Proposal 21: 3130-03-71, WISC 2025035
Whitewater to Elkhorn
CTH P to STH 20/67
USH 12
Walworth County

This is Addendum No. 02, which provides for the following:

ADDENDUM NO. 02

Addendum No. 02
ID 3130-03-71
Revised Sheet 322
November 7, 2024

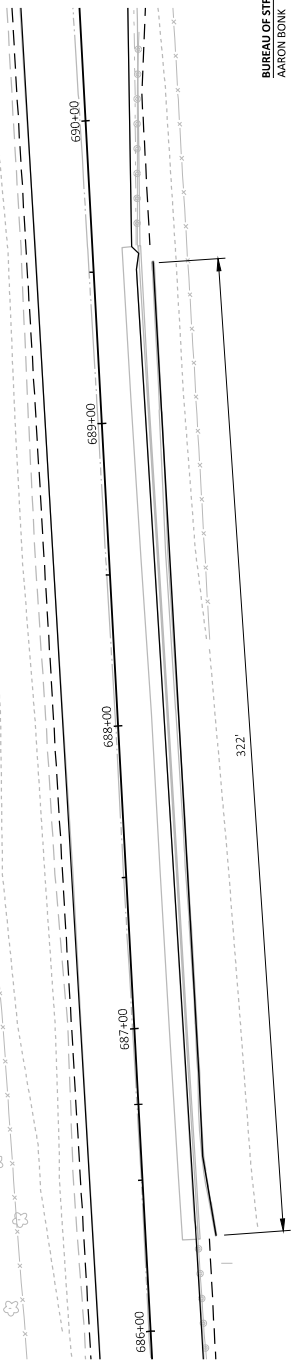
Revised Plan Sheets	
Plan Sheet	Plan Sheet Title (brief description of changes to sheet)
322	R-64-17 Structures Plan: Added note for acceptable material.

*2 ROWS OF 4-INCH TALL CAP WALL BLOCKS MAY BE USED AS AN ALTERNATIVE TO ONE ROW OF 8-INCH TALL CAP BLOCKS, PROVIDED BOTH ROWS ARE BONDED TO THE UNDERLYING LAYER OF BLOCK. TWO ROWS OF 4-INCH TALL CAP BLOCK WOULD REQUIRE STAGGERING THE VERTICAL JOINTS BETWEEN ROWS.
